EDGERTON PLANNING COMMISSION AGENDA  
SPECIAL SESSION  
Edgerton City Hall  
October 18, 2016  
7:00 PM

To: Edgerton Planning Commission  
 Fr: Kenneth Cook, AICP, CFM, Community Development Director  
 Re: PP2016-03 Preliminary Plat for Logistics Park Kansas City Phase III

To: Edgerton Planning Commission  
Fr: Kenneth Cook, AICP, CFM, Community Development Director  
Re: Application PS2016-03 for Preliminary Site Plan for Logistics Park Kansas City Phase III, First Plat

# Logistics Park Kansas City Phase III Preliminary Site Plan

Sheet  
C03

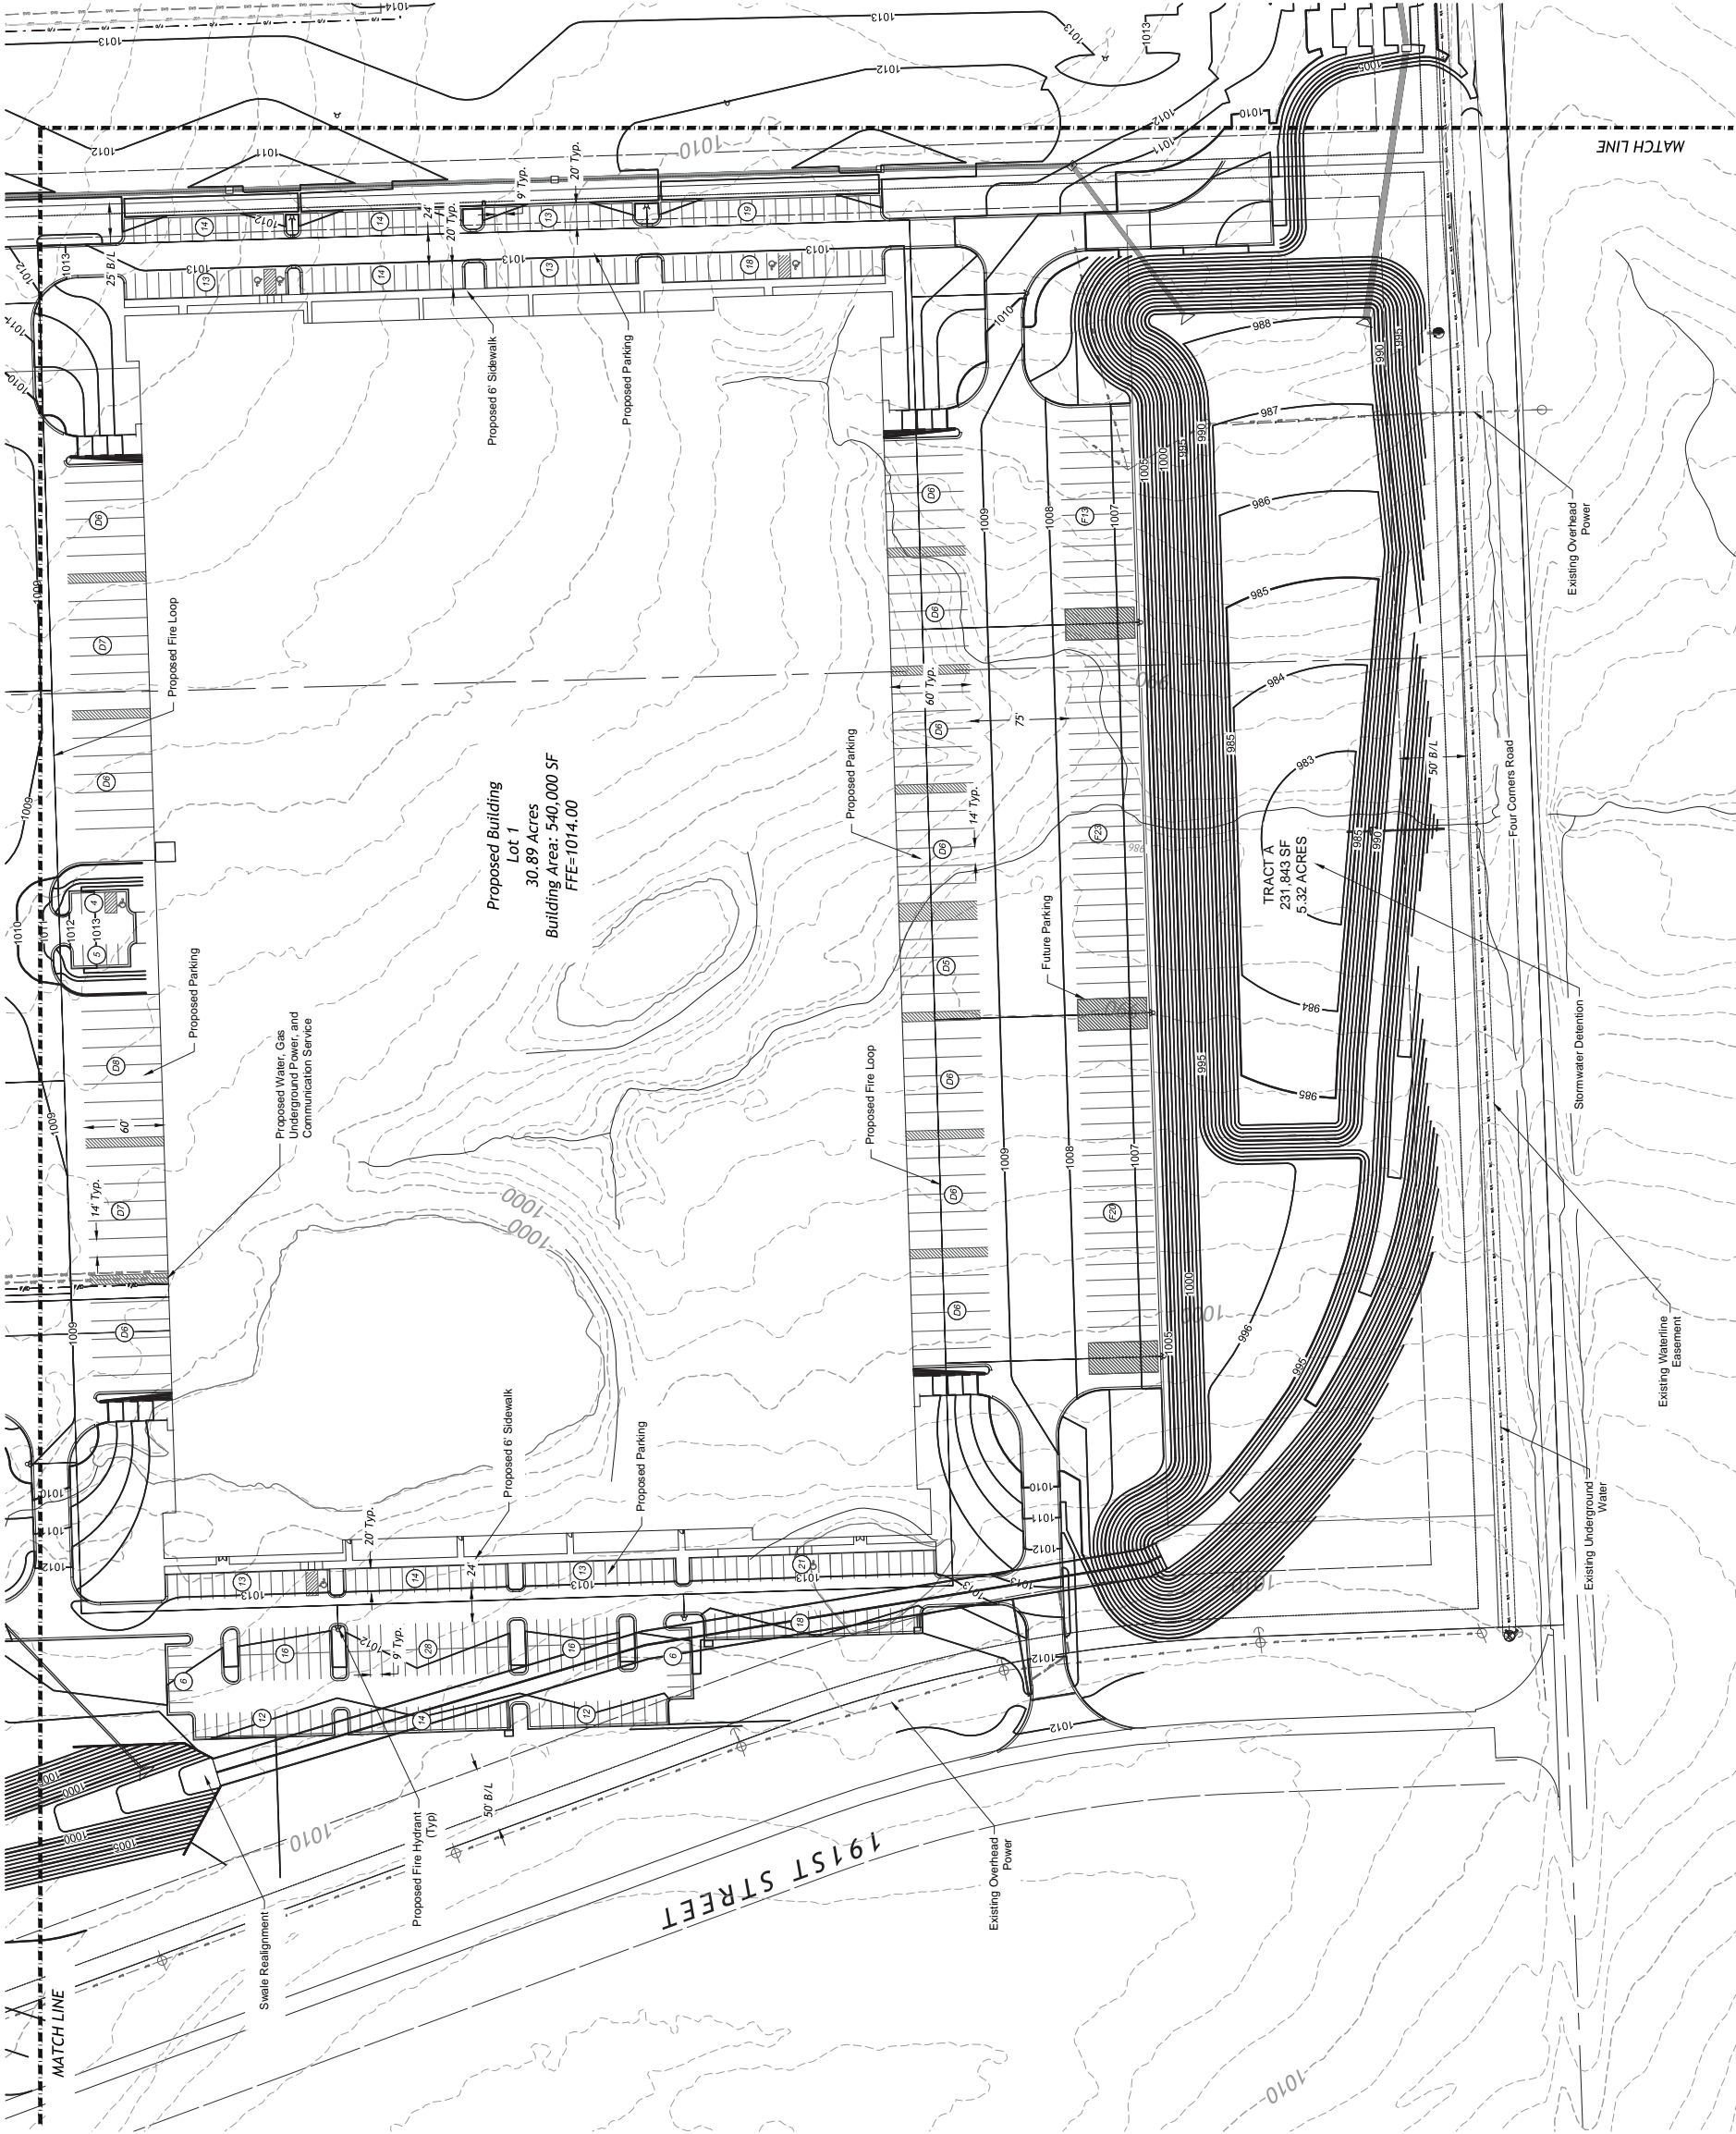
1. Front or cover sheet.
  - a) A scale vicinity map showing the relationship of the site to surrounding neighborhoods, roads and other physical features. *Show the proposed location of the proposed streets and also update the location of 191<sup>st</sup> Street as it was realigned in this area and is no longer located along the Section line and ends at Four Corners. **Make changes to name on the drawings.***

- b) A project title, zoning designation and project sponsor. A street, lot or tract address of the project. ***Preliminary Site Plan complies.***
  - c) An index to contents, and a data table which, at a minimum, includes: Acreage of the site and number of units per acre (if applicable); gross square feet of the building(s) area; the proposed use of each building; number of employees and the BOCA or Uniform Building Code or NEPA 101 Life Safety Code Occupancy Design Load and, the total number of parking places. *The number of parking spaces do not match the numbers shown on the plans. **Update Preliminary Site Plan.***

- iii) Location of buildings. ***Preliminary Site Plan complies.***
  - iv) Parking areas, paths, walks with sizes and surfaces material specifications. ***Pedestrian access needs to be provided from the sidewalks adjacent to the buildings to sidewalks on the proposed public roads. Connections need to be made to the South side of the building located on Lot 1 and the West side of the building located on Lot 2. Staff would suggest that sidewalks also be provided for the areas adjacent to Homestead Lane, 191<sup>st</sup> Street and Four Corners Road at the time that each of the adjacent lots are developed. The width of sidewalk along Homestead Lane should match the width of the pedestrian crossing over the bridge located to the Southeast of the site.***

*The current plan shows a new public road that would be located approximately half way between Homestead Lane and Four Corners Road. One site entrance is currently shown onto 191<sup>st</sup> Street and two entrances are proposed off of Four Corners. If Four Corners is not removed and is to continue as a public street, additional improvements will be needed and would require changes to the Plan of Finance. Staff is recommending that the Preliminary Site Plan can be approved with the specification that updates to the access on the Western portions of the site will be required as part of Final Site Plans for Lots 1 & 2. **Preliminary Site Plan Complies.***

2. All operations other than limited storage of motorized machinery and equipment, materials, products or equipment, shall be conducted within a fully enclosed building. *The site plan shows trailer parking areas along the sides of each of the proposed structures and does not show any other uses. The trailer parking area on the East side of lot 3 is located adjacent to Homestead Lane and staff suggests additional consideration for landscaping and screening in this area. The trailer parking area on the West side of Lot 1 will be located across the street from an existing dwelling and also the Big Bull Creek Park. The site plan currently shows a tract that will be used for drainage purposes that can act as a buffer between these uses but additional landscaping or berming should possibly be used as a transition between these different types of uses. **The Planning Commission may need to approve an alternative landscape plan in response to the unique characteristics of this site. This may need to include additional landscaping, fencing or berms, especially along the areas of ROW buffers or for loading docks. Additional information needs to be submitted with the Final Site Plan that take the unique characteristics of each lot into consideration.***

4. *Pedestrian access within a development and adjacent public and private property shall be considered as a component to the design of an employment center. Additional sidewalk connections need to be made to the North and South sides of the building on Lot 1 and the West side of the building on Lot 2. Staff also suggests that sidewalks should be provided on the adjoining streets (Homestead, 191<sup>st</sup> and Four Corners). The sidewalks located along Homestead Lane should match the width of the pedestrian crossing on the West side of the bridge. **Update Preliminary Site Plan.***

- The applicant should submit a stormwater study sealed by a Kansas Licensed Professional Engineer to be reviewed and approved by City Engineer.
- The proposed grading extends beyond the property line. Provide documentation from the adjacent property owner to show this is acceptable.
- The Name of the North-South Road should be changed in order to avoid confusion.

1. The above recommendations need to be incorporated into a Final Site Plan.
2. A Final Site Plan must be submitted and approved prior to commencement of uses and the property shall be developed in accordance with a Site Plan, Landscaping Plan, and Photometric Plan as required by City approval of the submitted preliminary site plan, as amended by these stipulations, and approved by the City.
3. Final Site Plans submitted for Lot 1 and Lot 2 may require modifications as Four Corners Road is currently anticipated to be removed.

4. All Preliminary Site Plan requirements of the City listed above shall be met or addressed during Final Site Plan submittal as identified above.
5. No signage is proposed with this application. Signage proposed later shall receive separate approval according to the provisions of the UDC.
6. All construction plans for any public infrastructure shall be prepared to City standards and approved by the City.
